Request	DTC Modifications
Project Name	127 Rosa L. Parks Boulevard
Council District	19 – O’Connell
Requested by	Lee Davis, with ESa;
Staff Reviewer	Hammer
Staff Recommendation	<i>Approve with conditions and defer without all conditions</i>

Downtown Code DRC Meeting of 9/5/2019

Figure 8: Location of Outdoor Dining Area

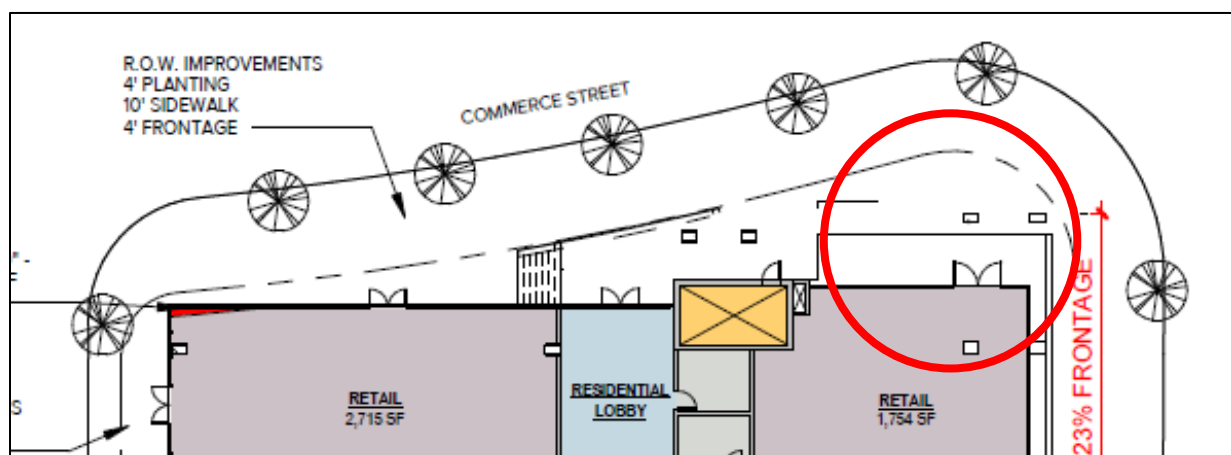
Buildings with storefront frontage along primary streets are required to have a 0-10' build-to zone, defining 80% of the frontage. The area in red illustrates frontage not built to the required build-to line. Commerce Street was created by widening Cumberland Alley and joining it to Payne Street, although the two were offset from each other. The alignment of the resulting right-of-way creates an oddly shaped frontage on this site that coincides with somewhat challenging topography.

The intent of the shallow build-to zone is to create a close relationship between buildings and the public realm, activating the sidewalk corridor. In this case, the portions of the building that are not within the build-to zone are intended for outdoor dining and serve as an extension of the active retail and restaurant uses proposed within the ground floor of the building. The proposed build-to zone meets the intent of the DTC.

Figure 9: Rosa Parks Boulevard Frontage

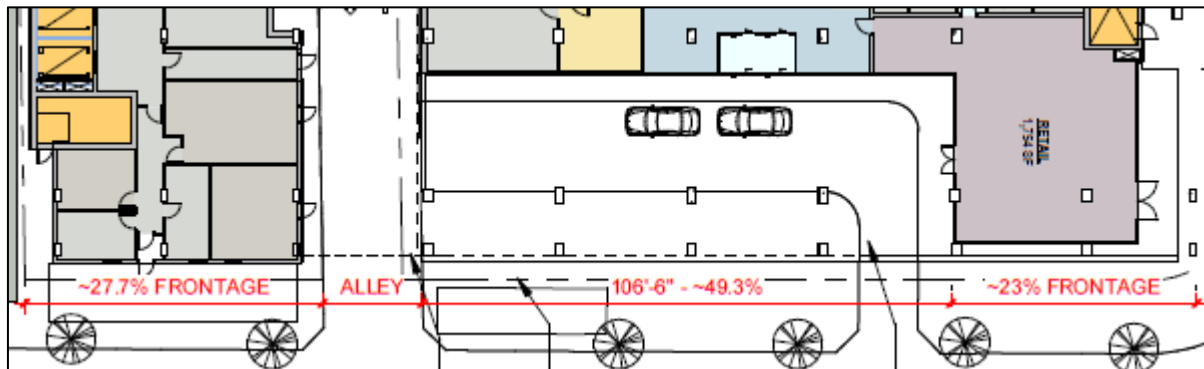
Buildings with storefront frontage along primary streets are required to have a 0-10' build-to-zone, defining 80% of the frontage. The building's ground floor façade on Rosa L Parks Boulevard is recessed in order to accommodate a porte cochere, resulting in 50.7% of the façade being within the 0-10' build-to zone.

The proposed configuration minimizes negative impacts to the sidewalk corridor. It utilizes the alley for exiting the porte cochere and is limited to one entry of 12 feet in width. For a hotel of this scale, off-street drop-off facilities are both necessary and often preferable to on-street facilities that further disrupt pedestrian activities along the sidewalk corridor.

Figure 10: Areas of Ground Floor Façade that Encroach into the Frontage Zone

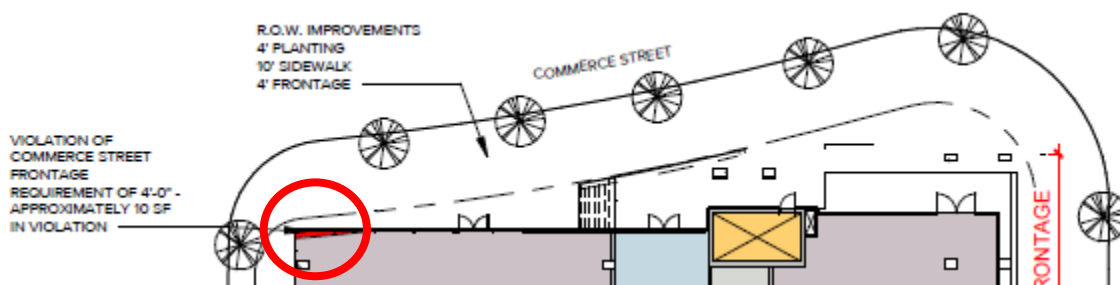
In this case, a portion of this façade is within the frontage zone for with a maximum 1.5 foot encroachment. As the building is seeking other modifications with the explicit purpose of activating the exterior of the building with outdoor dining and other pedestrian amenities, which is the intent of the frontage zone, this modification is in keeping with the intent of the frontage zone and the encroachment proposed is negligible.
